SEWAGE DISPOSAL SYSTEM

DEPARTMENT OF HEALTH AND MENTAL HYGIENE

SUBDIVISION Warfield Estates LOT 2, Blk C ROAD 3316 Stapleton Drive

REPAIR - PURPOSE - SEPTIC SYSTEM HAS FAILED.

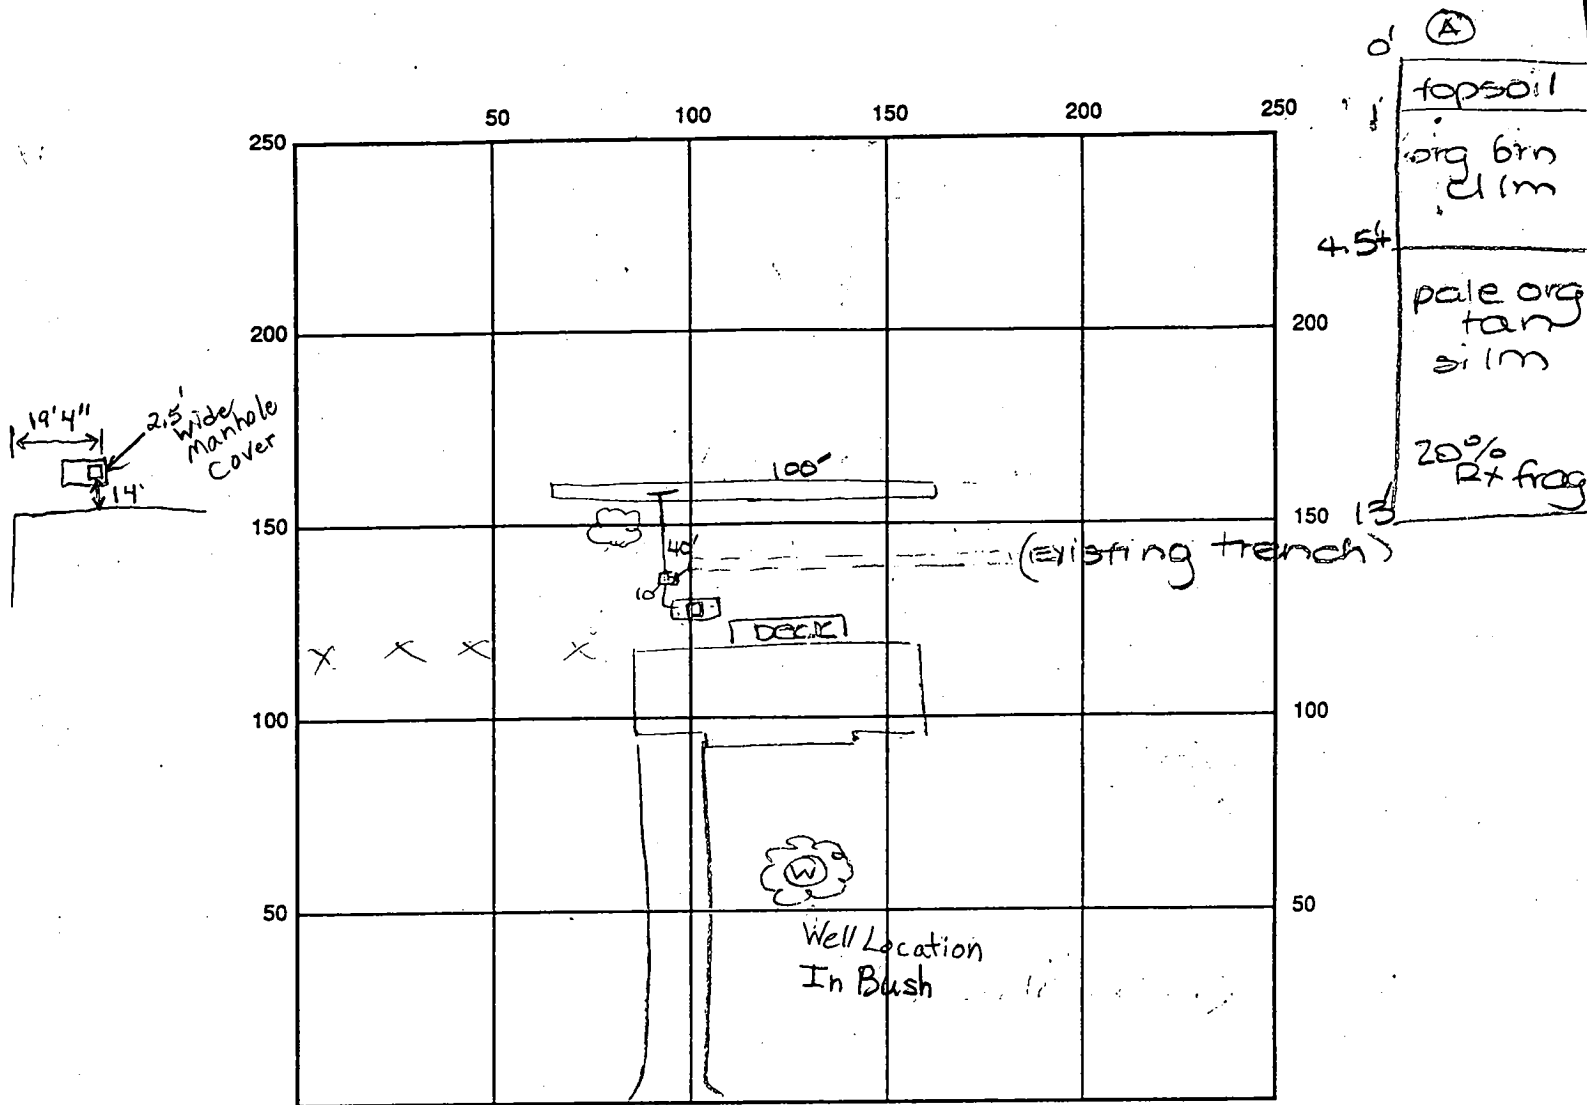
Install trench off existing system along contour
Trench to be 2' wide, inlet 4.5', bottom 10', stone 5.5'

REMARKS: 5/19/98 OK to install trench as specified. DKS
5/19/98 P.M. - FINAL INSP - OK to cover all work. DKS

LOCATION SURVEY
 OF

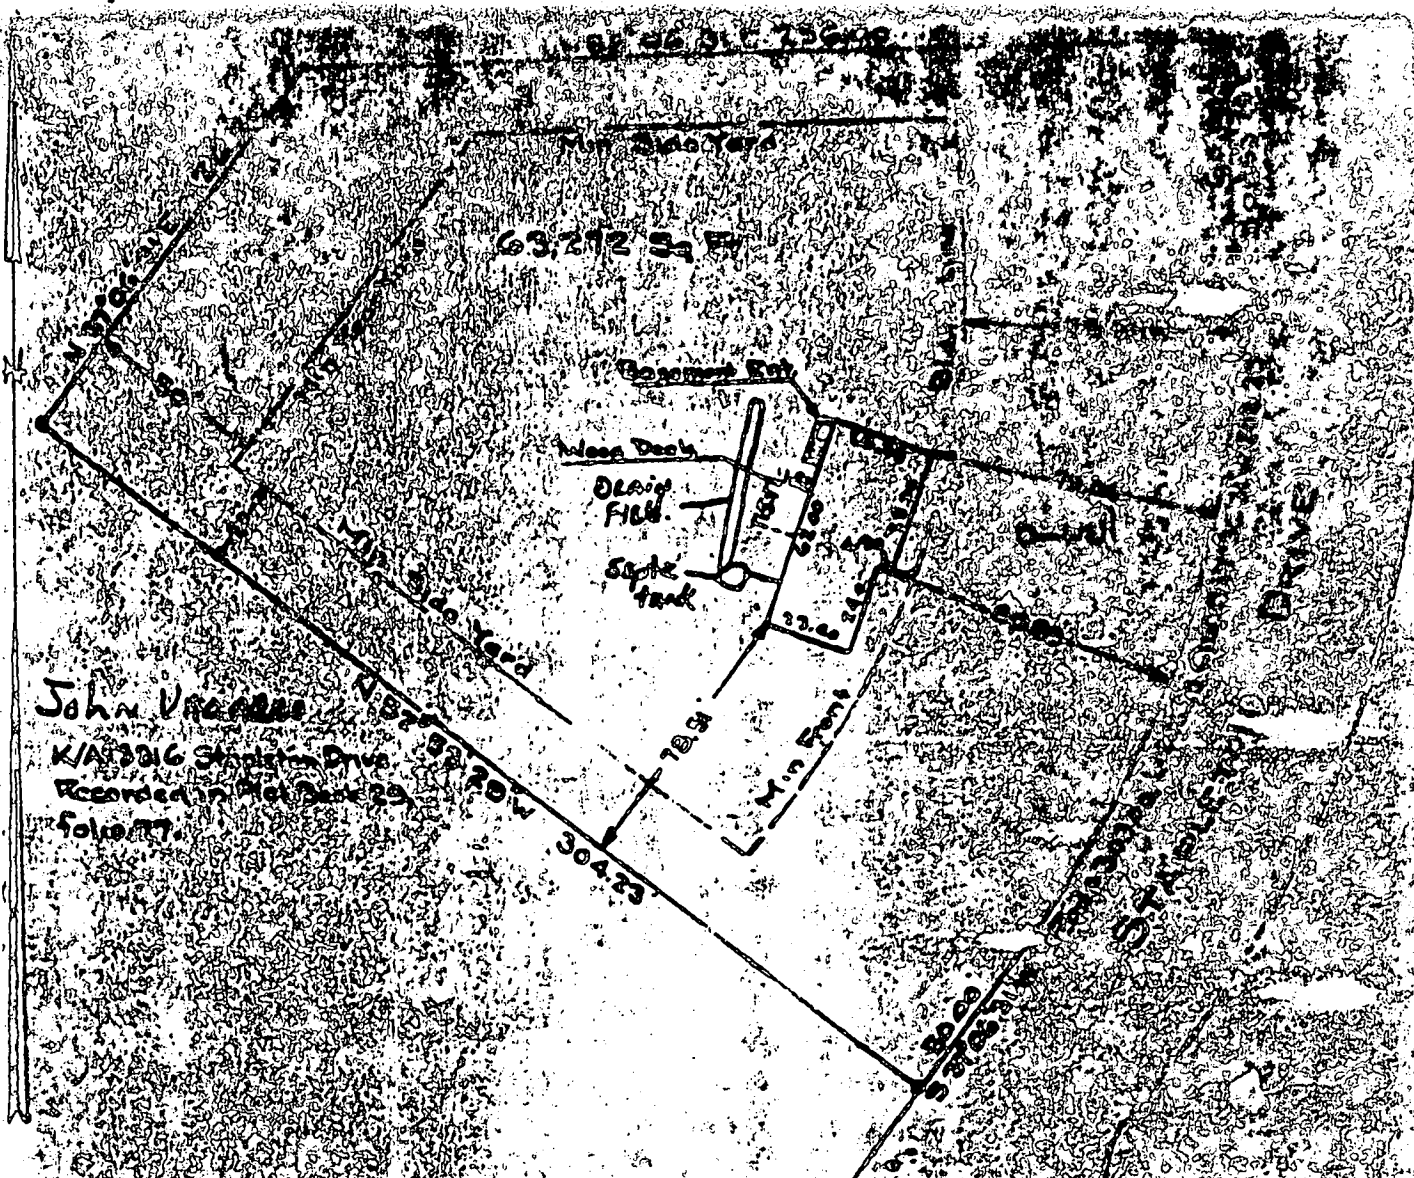
Needs Site
Inspection

Easement?

Tank too close
to proposed deck
~ 1' from proposal
(BB)

Told Deck Contractor
That Septic Tank
Would Have To Be
Moved If Deck Is
To Be Built, Existing
Trenches To Remain
In Use - Adequate Repair
Area on Lot (AB)
